CCL Ref: 14710-280421-lindsay

Tunnel Beach Road Car Park: Assessment of Application

Further to our e-mails and discussions, we have reviewed the application for a car park at Tunnel Beach Road. Our comments are set out below, and are based on:

Figure 2: Proposed Revisions for Drawing

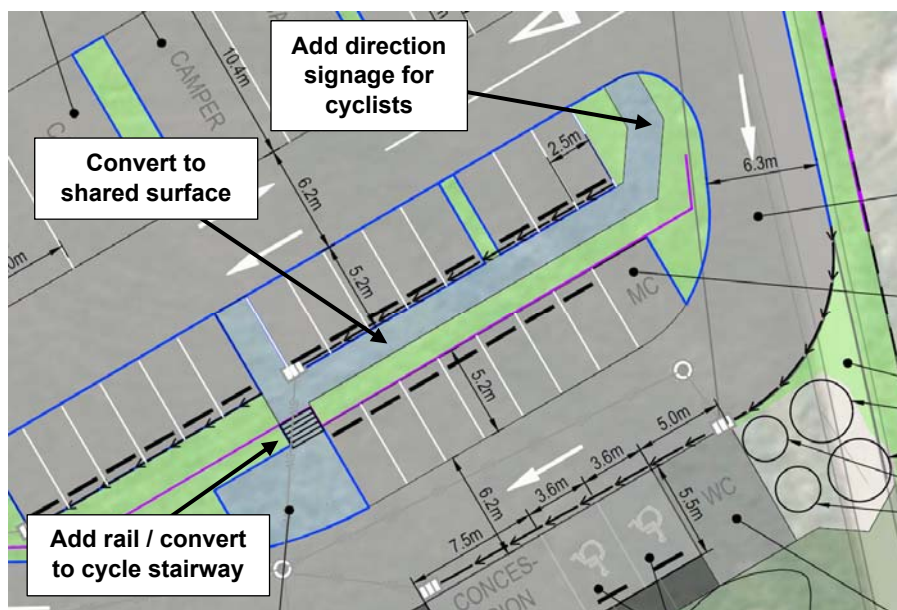
The application sets out that “no cycling facilities have been included in the proposed design”. However the plans provided in response to the s 92 request show cycle parking stands located towards the south of the site.

Because there are steps located on the northern side of this area, at present cyclists will need to share the southernmost aisle with moving cars and coaches. Car drivers will also be reversing into this aisle. Each of these presents a potential road safety concern for cyclists also using the aisle.

The pathway to the north and east of the cycle parking area is 1.8m wide. This is only slightly less than the minimum width for a shared walking and cycling route (2.0m) and we note that cyclists could make use of the adjacent grassed area to avoid any conflict with pedestrians. We also expect that cyclists will be travelling slowly in this area (and may have even dismounted). As such, we consider that the plans should be updated to show a cycle stairway (that is, a channel/rail alongside the steps to allow a cycle to be pushed up or down), and that signage should be provided at the eastern end of the pathway to indicate that it is the route to be used by cyclists. We consider that

these measures will mitigate the potential road safety risk arising from the cycle parking in this location and therefore recommend that a condition of consent is put in place for this.

We have recommended that minor revisions are made to the arrangements for cycle parking to ensure that the parking can be accessed safely, and that this is addressed through a condition of consent. We have also recommended a condition of consent in respect of signage for the coach drop-off area indicating that longer-term parking is not permitted. We suggest a P10 or P15 sign would be appropriate.
